Title: Valor on Washington

Re: Urban Design Commission Application - Final
Valor on Washington: 1322 East Washington Avenue

Enclosed are updated plans for the project known as Valor on Washington. In response to feedback at the June 12, 2019 UDC meeting, we have made the following adjustments:

SHEET NUMBER:
L1.1

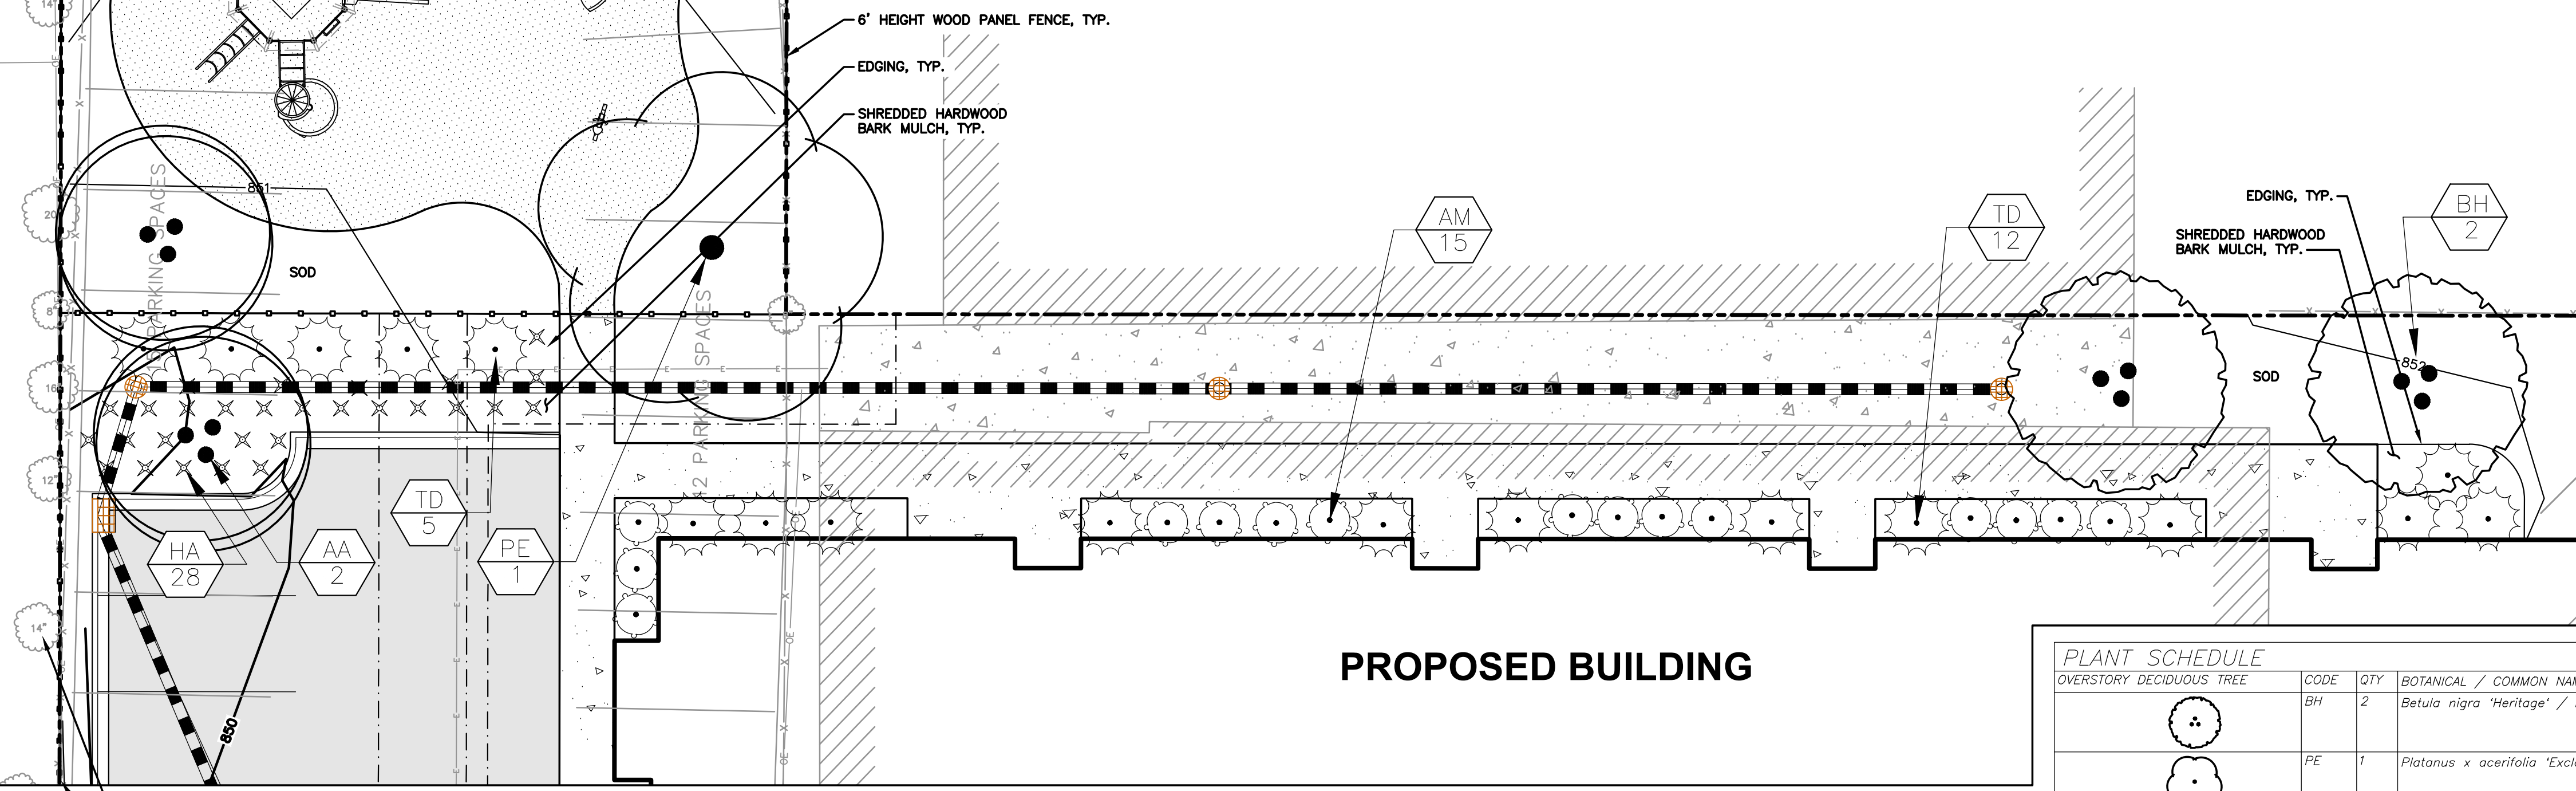
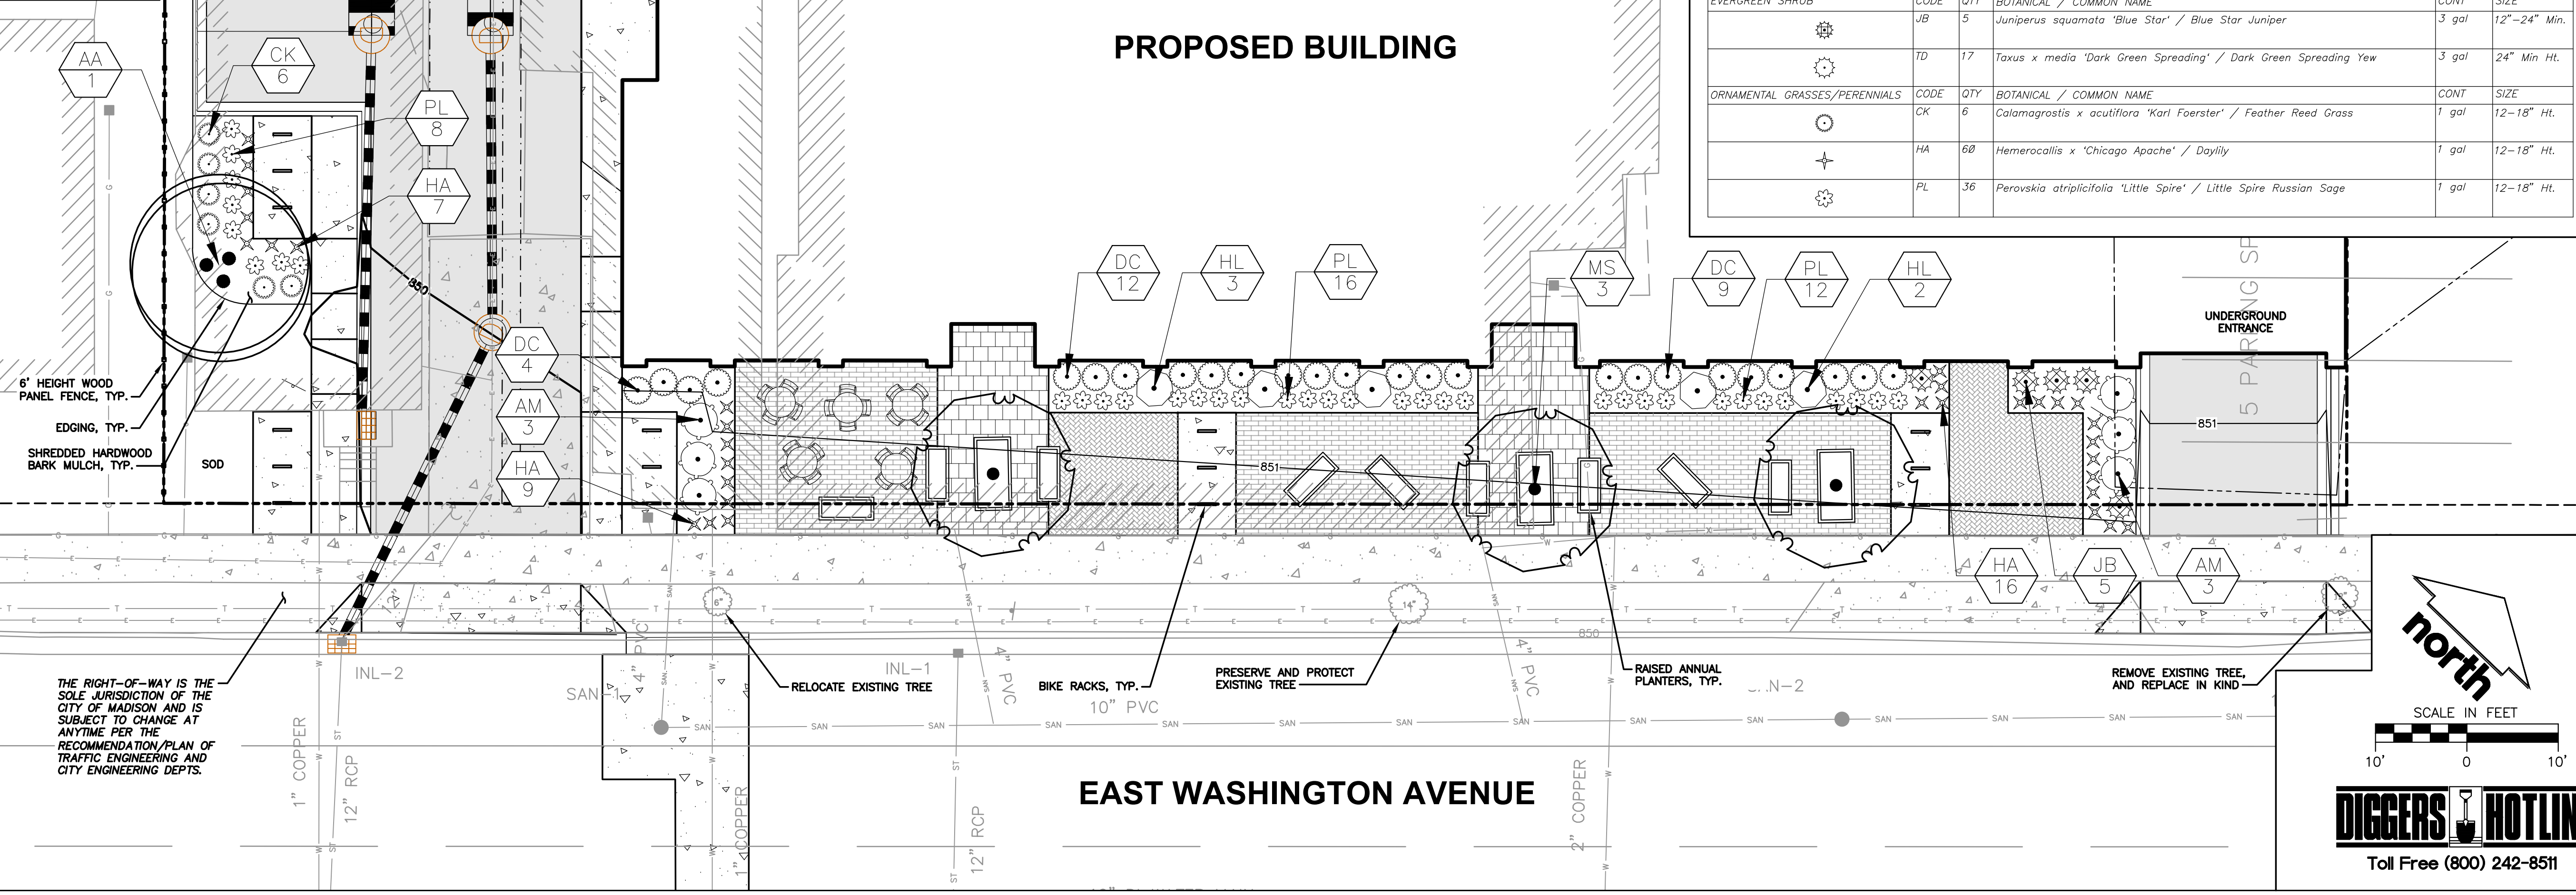
- (3) Cleveland Select Pear ornamental trees in front terrace have been removed and replaced with 'Spring Snow' Crabapple species
- 4x8 tree grates added for ornamental trees in front terrace
- Playground Area - (1) rear ornamental tree replaced by larger canopy shade tree on south east corner of playground

Sheet No.
A171

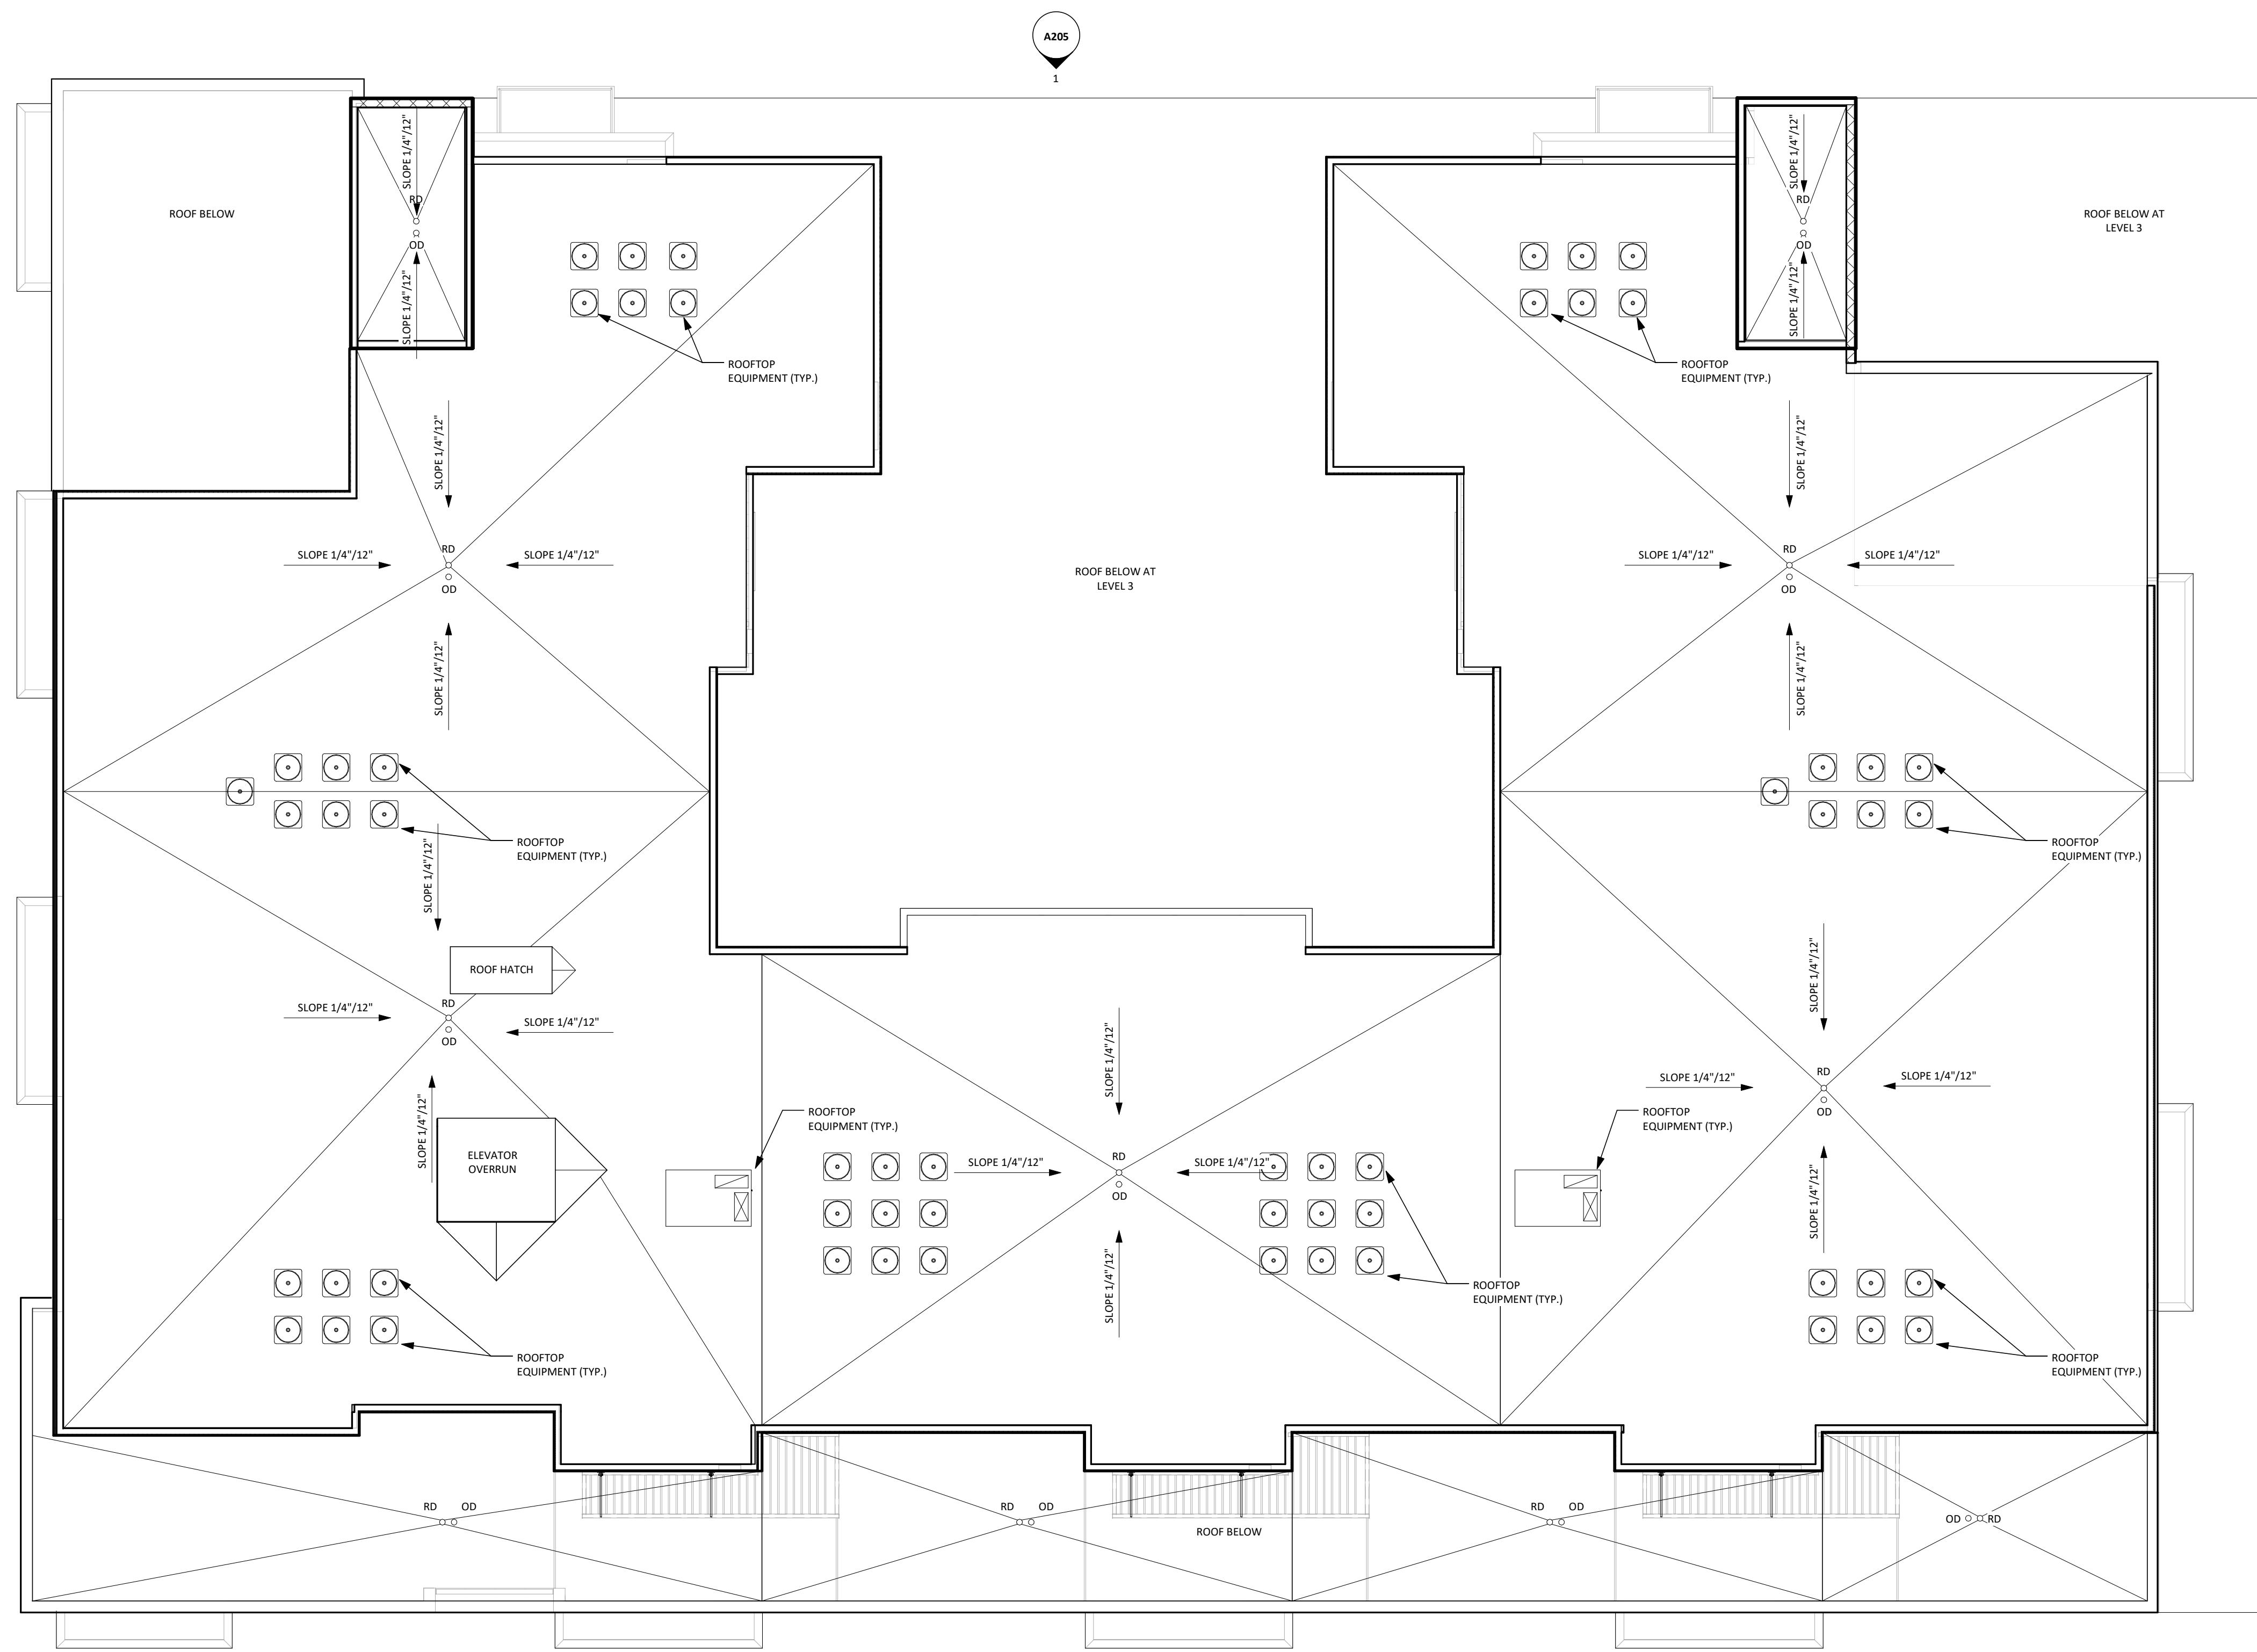
- *Provide more information on roof plan, including any landscaped areas and rooftop mounted mechanical equipment:* Roof plans for the lower and upper roofs are enclosed. There are no rooftop condensing units on the lower roof at level 3. Rooftop condensing units for the residential units, are shown at the upper roof plan. Additionally, (2) RTU's are shown on the upper roof plan, (1) for the commercial suite and (1) for resident amenity areas.
